# PREVOST

# WARRANTY BULLETIN

WB23-27

SUBJECT: PARCEL RACK DOOR DECALS REPLACEMENT

# First parcel rack door curbside

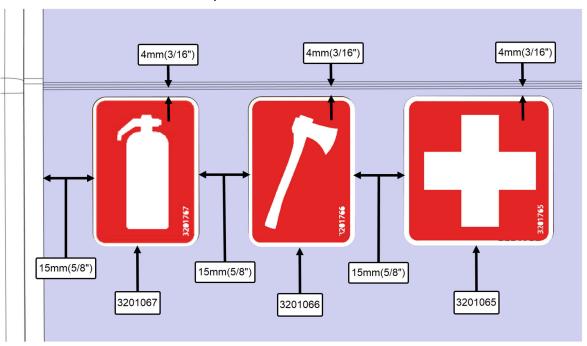
- 1. Locate the door with decals:
  - First parcel rack door curbside: "Extinguisher", "Chopped" and "First Aid".
  - Third parcel rack door streetside: "Extinguisher".
- 2. Mark the position of each decal with masking tape.

- 3. Remove old decals on the parcel rack door.
- 4. Clean the surface with alcohol.
- 5. Install new decals:
  - First parcel rack door curbside: "Extinguisher" 3201067, "Chopped" 3201066 and "First Aid" 3201065.
  - Third parcel rack door streetside: "Extinguisher" 3201067.
